Certificate of Appropriateness

Property 807 W. HISTORIC MITCHELL ST.
Description of work Rebuild the North elevation of the building from the second floor sill detail to the parapet.
Existing material and detailing to be retained; portions of the roof flashing to be replaced.
Parapet coping to be properly flashed. See attached drawings.
Date issued 11/1/2022 PTS ID 115343 COA: MASONRY FACADE REPAIR

FACADE RESTORATION 807-811 WEST HISTORIC MITCHELL STREET MILWAUKEE, WI 53204

1 BUILDING ELEVATION
SCALE: 1/2" = 1'-0"

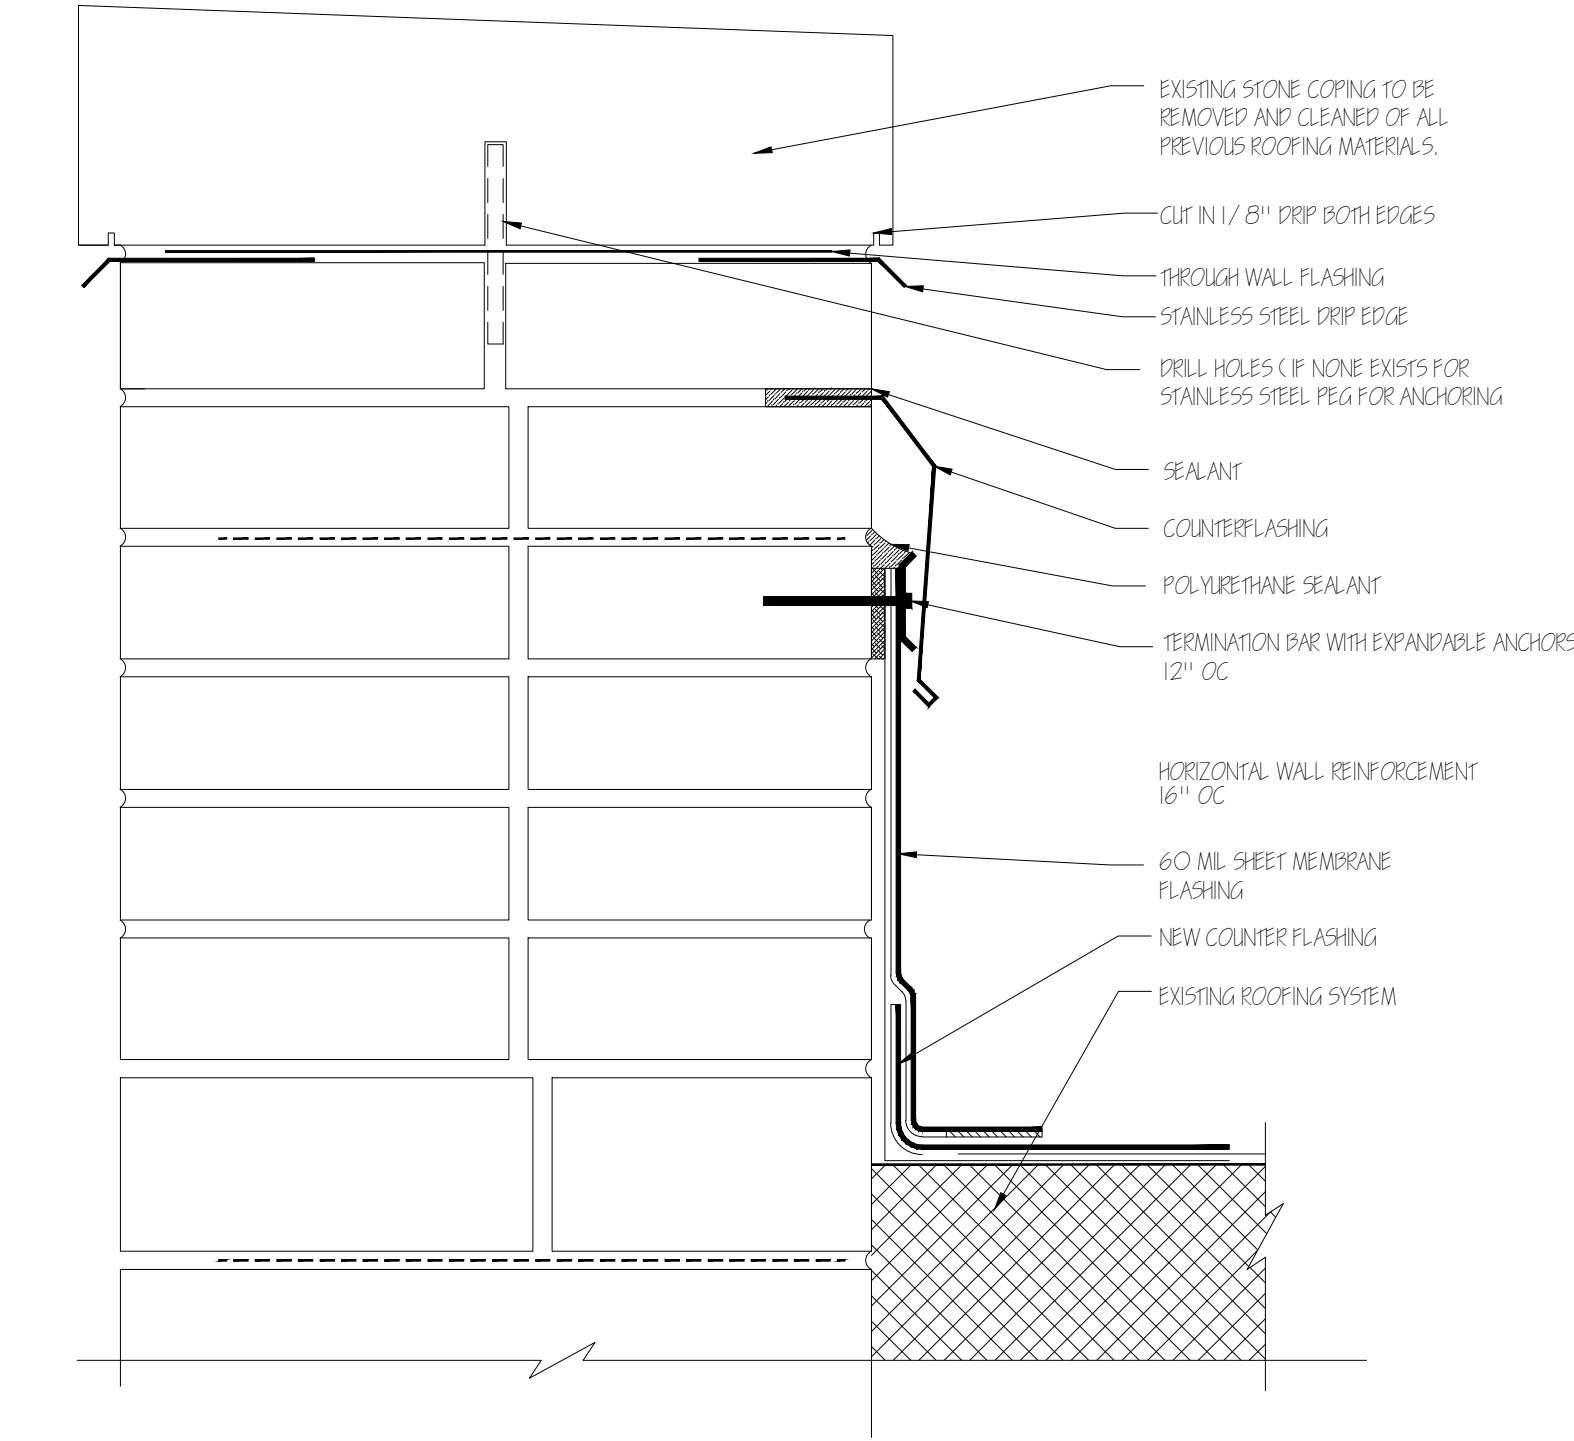
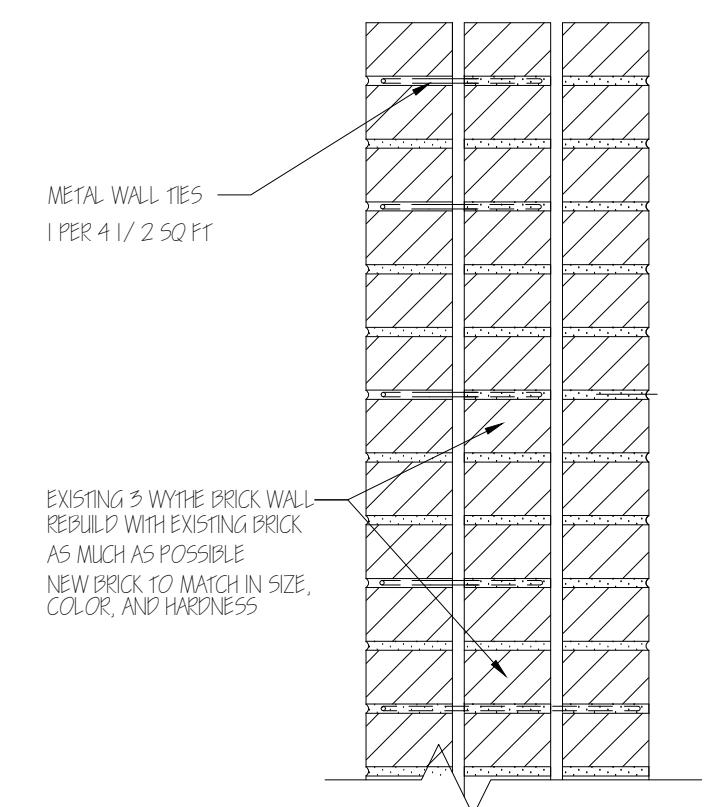
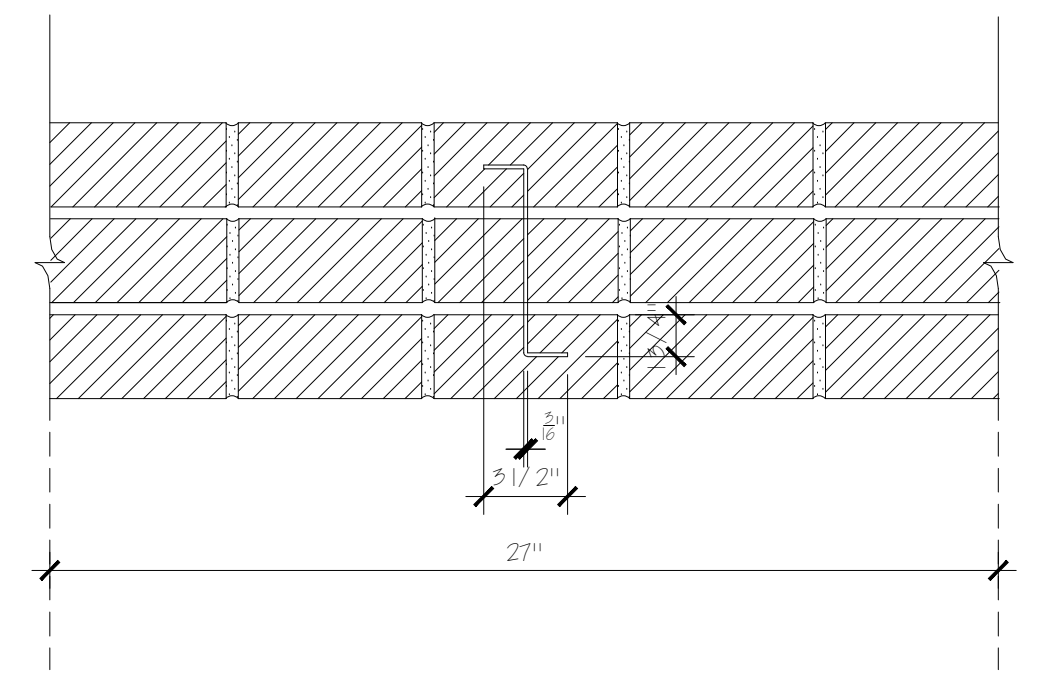
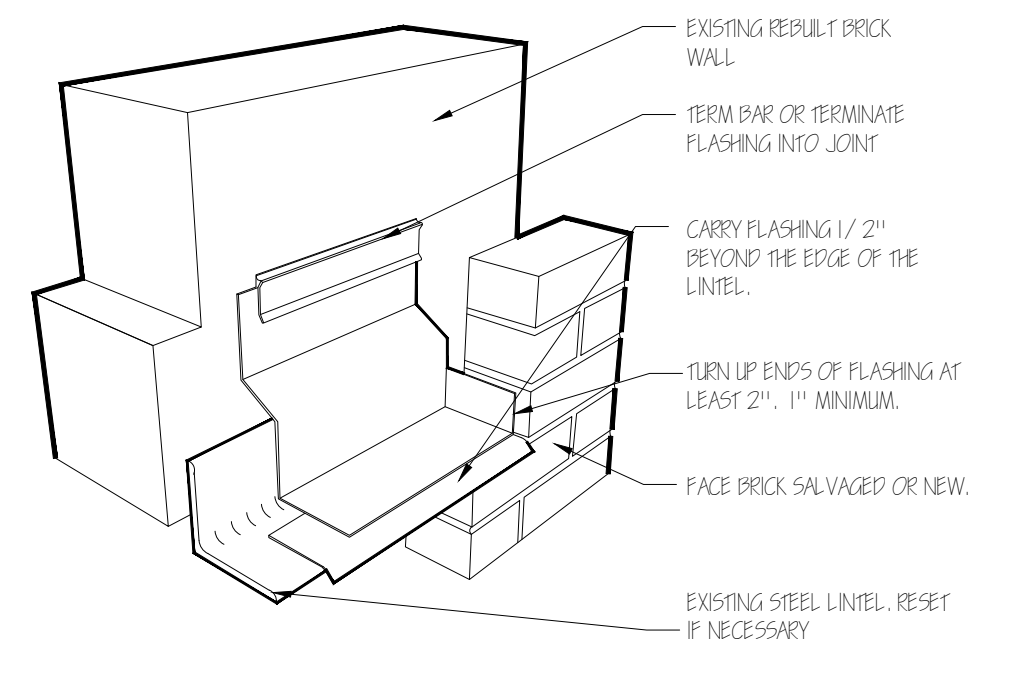
New mortar must match the original mortar in terms of color, texture, grain size, joint width, and joint finish/profile. The compressive strength of the repointing mortar shall be equal or less than the compressive strength of the original mortar and surrounding brick or stone. The replacement mortar shall contain approximately the same ingredient proportions of the original mortar. Mortar that is too hard is subject to premature failure and could damage the masonry. See the city's books *As Good As New* or *Good for Business*, Masonry Chapters, for more information. In most cases, this means a lime mortar with natural hydraulic cement rather than Portland cement. No joint of a width less than 3/8" may be cleaned of damaged/decomposed mortar with power disc grinders. No over-cutting of the joints is permitted. Remove decomposed mortar back into the wall 2.5 times the height of the joint before repointing. When installing new flashing at a masonry feature, the flashing must be stepped or cut into the mortar joints. The bricks may not be cut to install flashing at an angle.

New brick/stone/terra cotta must match as closely as possible the color texture, size, and finish of the original.
A sample panel of the masonry materials and their mortar must be reviewed and approved by HPC staff prior to general installation of the material.
